**RE: RESPONSE TO INFORMATION REQUEST
SECTION 13.2 OF THE DEVELOPMENT ASSESSMENT RULES
86 KEONA ROAD, MCDOWALL QUEENSLAND 4053**

- Reconfiguring a Lot – Subdivision (1 Lot into 13 Lots and new private road)

Figure 1 – Public transport stops within proximity of the site

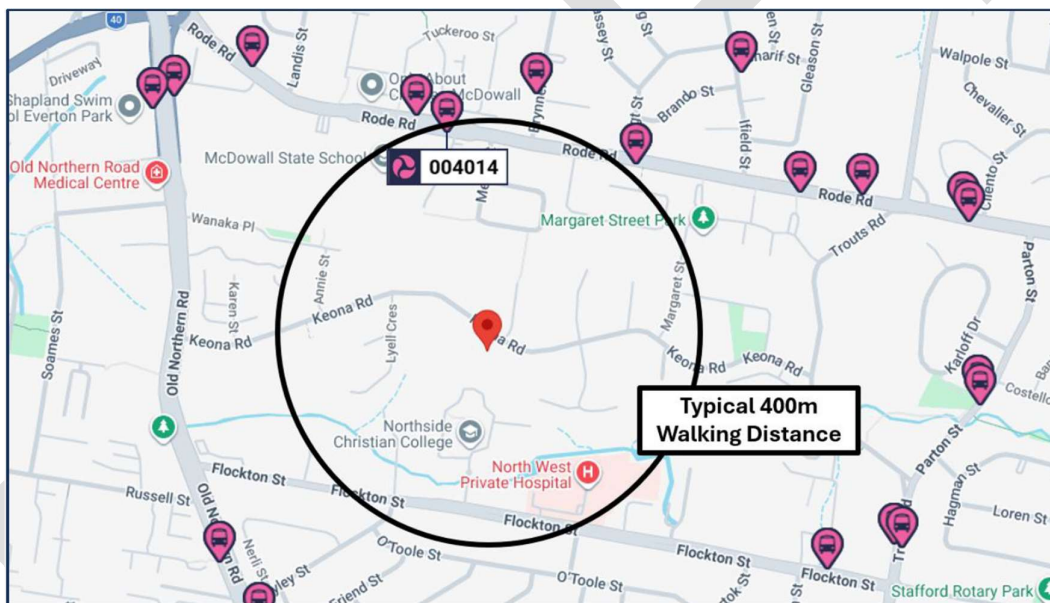
- a) Provide further justification demonstrating the walking distance between the subject site and the nearest public transport stop; and
- b) Provide further information and amendments demonstrating that the proposed dwelling density is consistent with the density of comparable subdivisions within the Emerging community zone in the surrounding locality.

Response: The site can service increased density given its proximity to schools, centre zoned land, childcare, healthcare, parks, open space and public transport. Council has specifically requested detail to the nearest public transport stop - The figure below shows there are multiple bus stops on Rode Road and Old Northern Road, and that at least two of these are located within approximately 400m of the site.

Figure 2 – New road centreline longitudinal section

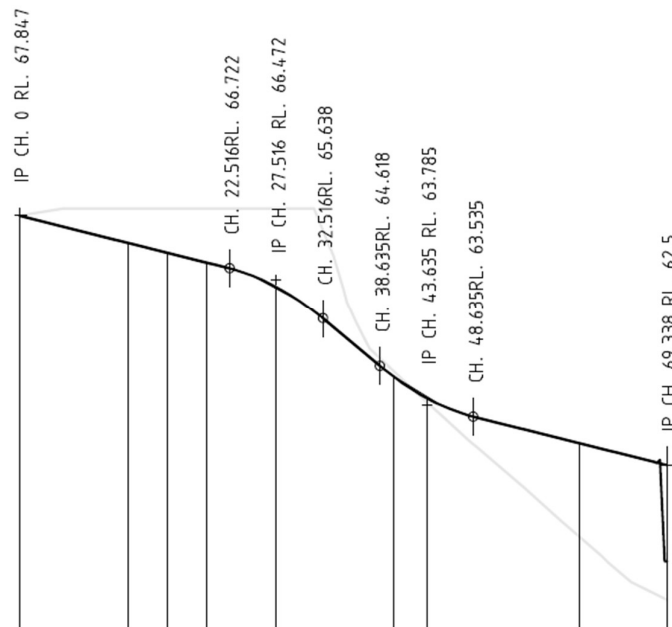
- a) *Submit amended plans, demonstrating:*
 - i) *Retention of trees along site boundaries in accordance with AS4970 'Protection of trees on development sites'.*
 - ii) *Lot layout and lot sizes to accommodate building envelopes as well as NRZ of retained trees.*
 - iii) *All earthworks excluded from NRZ; and*
- b) *Submit an earthworks plan, demonstrating no fill, cut or services are located within an NRZ.*
- c) *Submit an arborist report, prepared by an AQF Level 5 qualified arborist, outlining protection measures where earthworks are proposed to more than 10% of an NRZ.*

A major consideration in the required earthworks is the internal road which is cut to a maximum grade of 16.7% in order to take up the grade quickly to reduce the height of retaining at the southern boundary, which interfaces with the school. The ability for the road to take up grade is complicated by the requirement of the Refuse Planning Scheme Policy which limits the grade of refuse collection maneuvering areas (the t-head) to a maximum of 5%, requiring the lower end of the site to be lifted (filled). These works relative to the existing topography are illustrated in **Figure 2** below.
